NOTICE OF SPECIAL MEETING

**City Council
3800 Laverne Avenue North
Tuesday, July 22, 2014
6:00 PM**

AGENDA ITEM: Lakewood Crossing Preliminary Plat and Final Plat; Kwik Trip Conditional Use Permit

PLANNING COMMISSION
DATE: 7/14/2014
AGENDA ITEM: 4A – PUBLIC HEARING
CASE # 2014-37

LAKEWOOD CROSSING

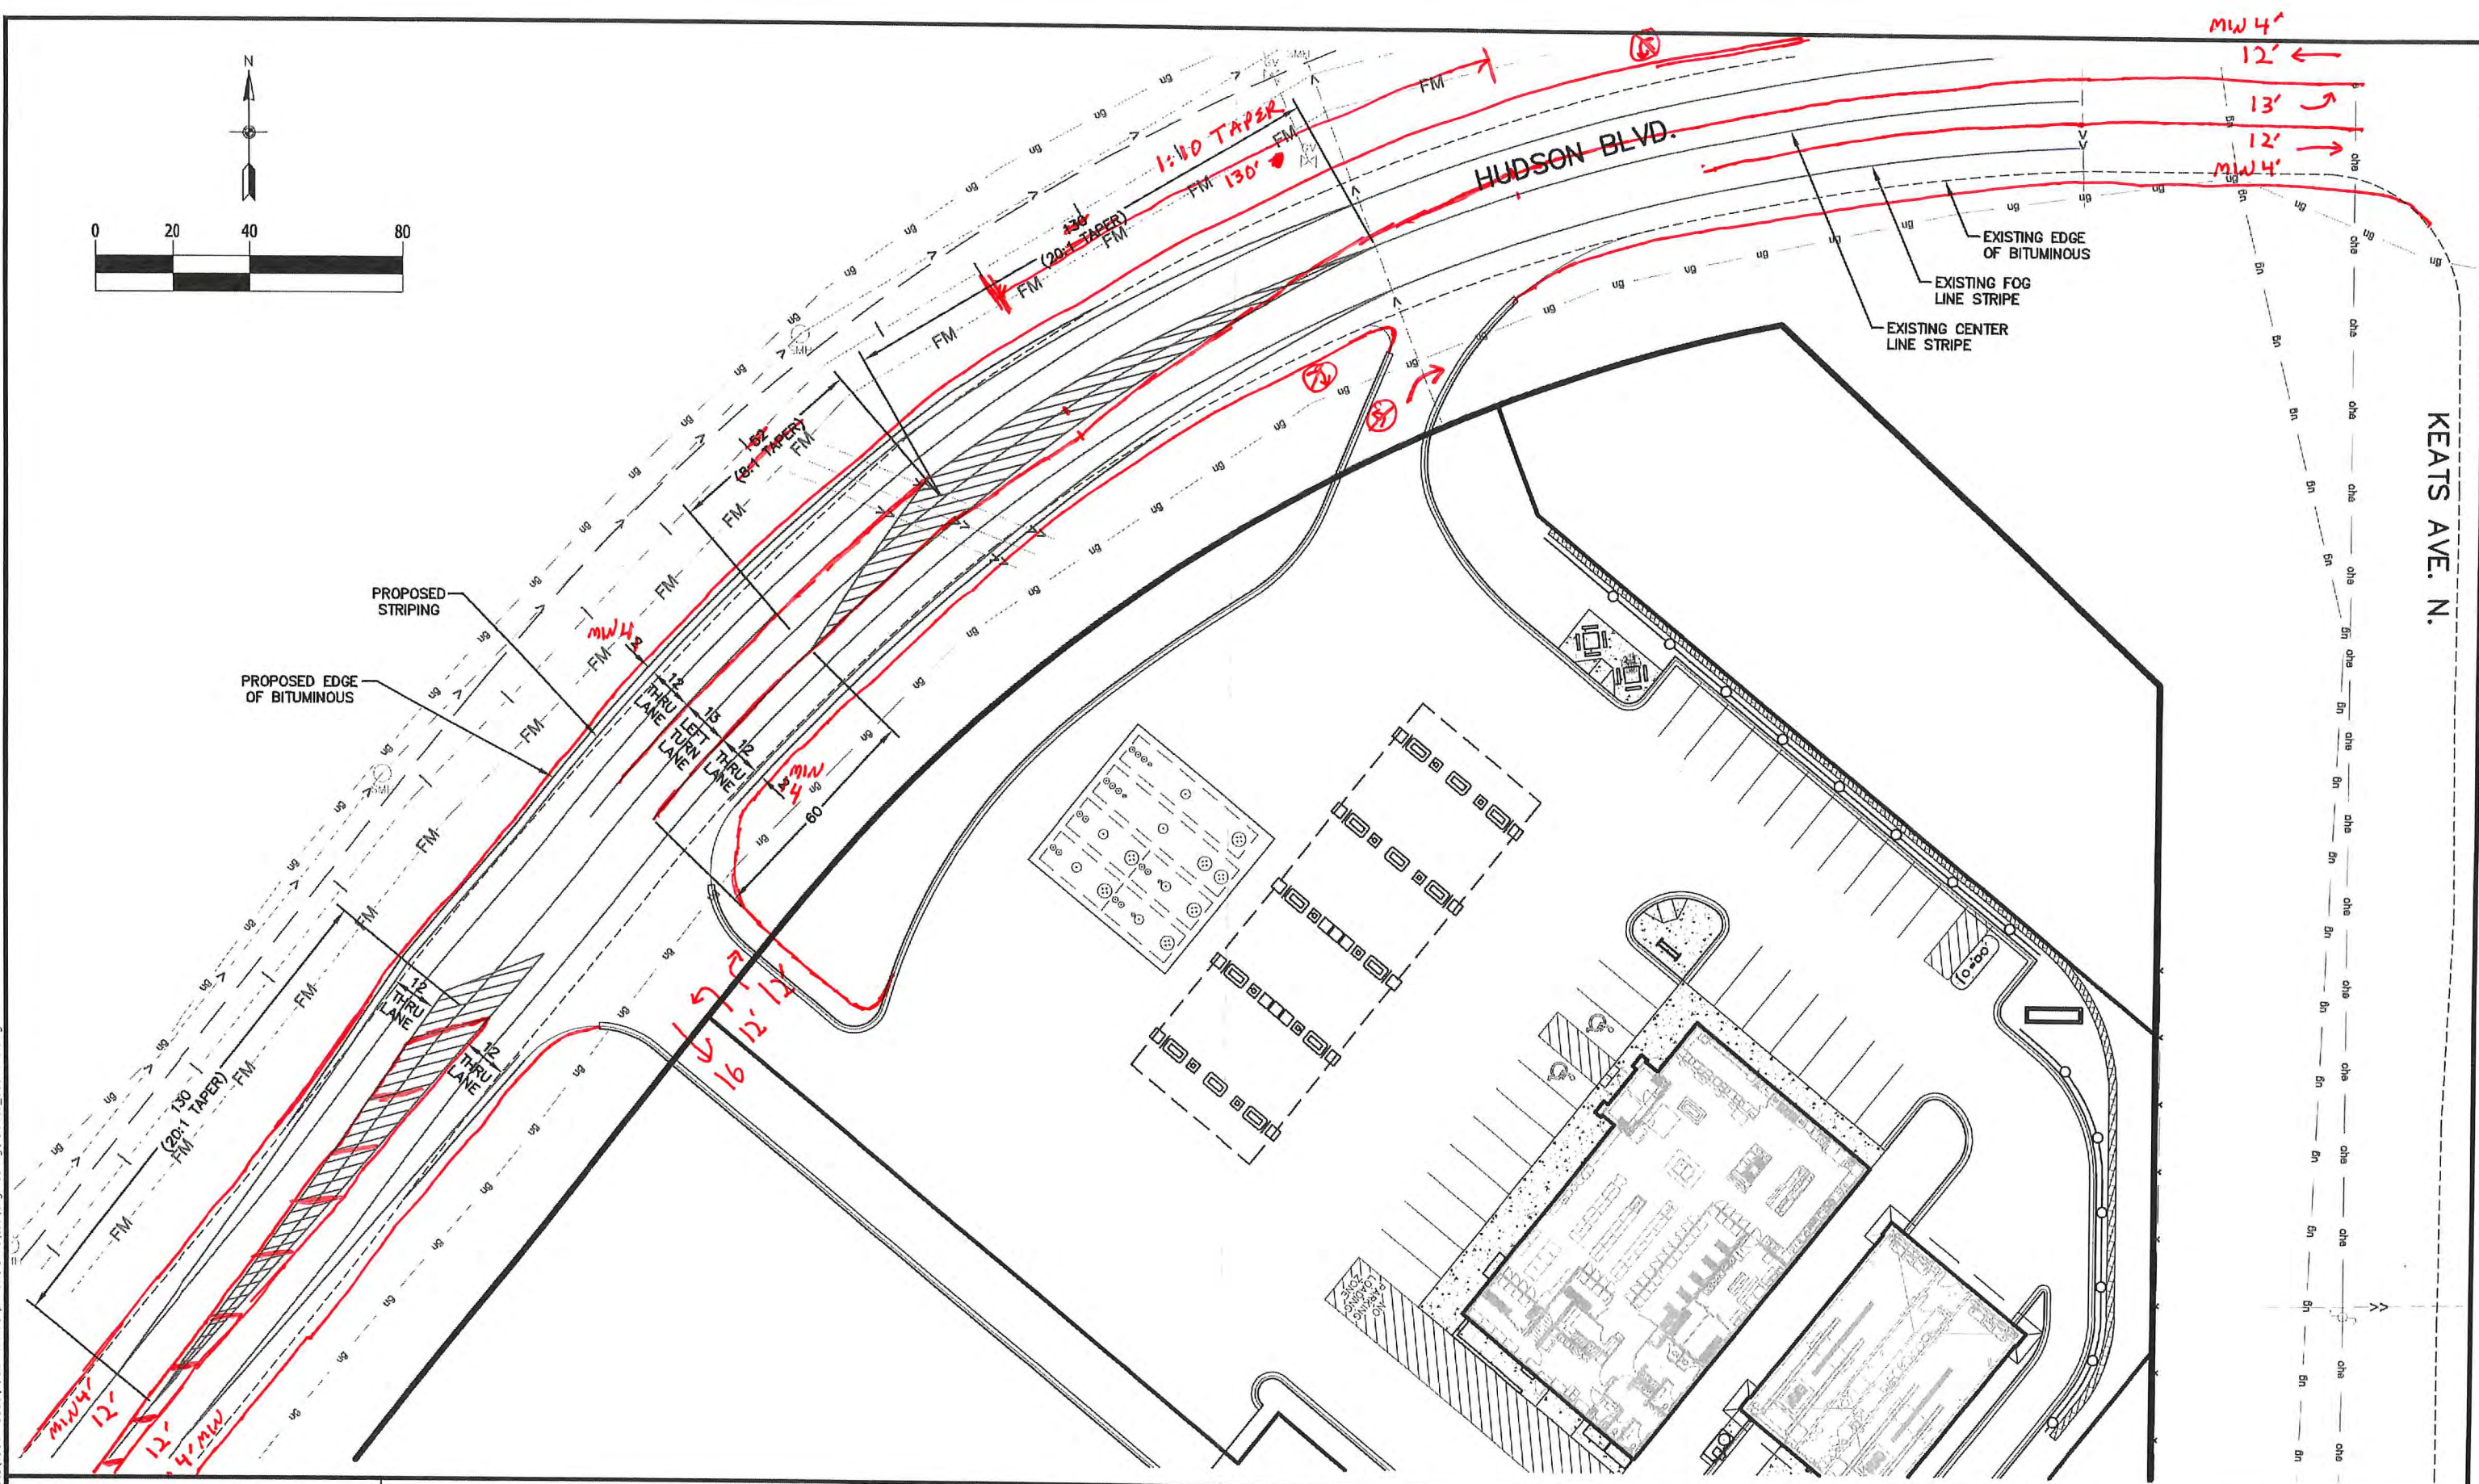
Per your request, we have reviewed the Turn Lane Exhibit for the Lakewood Crossing, dated June 11, 2014, and sent for our review on June 18, 2014. The exhibit shows two points of access for the site, both off Hudson Boulevard. A westbound left-turn lane from Hudson Boulevard into the site is established through restriping and limited pavement widening. The exhibit is attached to this memorandum for reference.

Our review focused on the ingress and egress of the site, particularly the proposed design of the turn lane on Hudson Boulevard. Based on this review, our comments are:

- Keats Avenue is a County State Aid Highway and an A Minor Arterial. The City's 2030 Comprehensive Plan lists an existing average daily traffic of 6,100 vehicles per day on this roadway. Hudson Boulevard is a local frontage road, proposed to be a Major Collector in the future. It has an average daily traffic volume of 1,300 as listed in the City's Comprehensive Plan. The exhibit shows that the site, appropriately, will be accessed from Hudson Boulevard, which is both lower on the hierarchy of roads and carries less traffic than Keats Avenue.

- The west access should be planned for full access into and out of the site. It is proposed to be located farthest from the Hudson Boulevard/Keats Avenue intersection (~550 feet), which will limit the interaction and influence of operations between these two intersections. The width of this driveway should be at least 40 feet to accommodate one inbound lane (16 feet wide) and two outbound lanes (left-turn lane 12 feet wide and right-turn lane 12 feet wide).
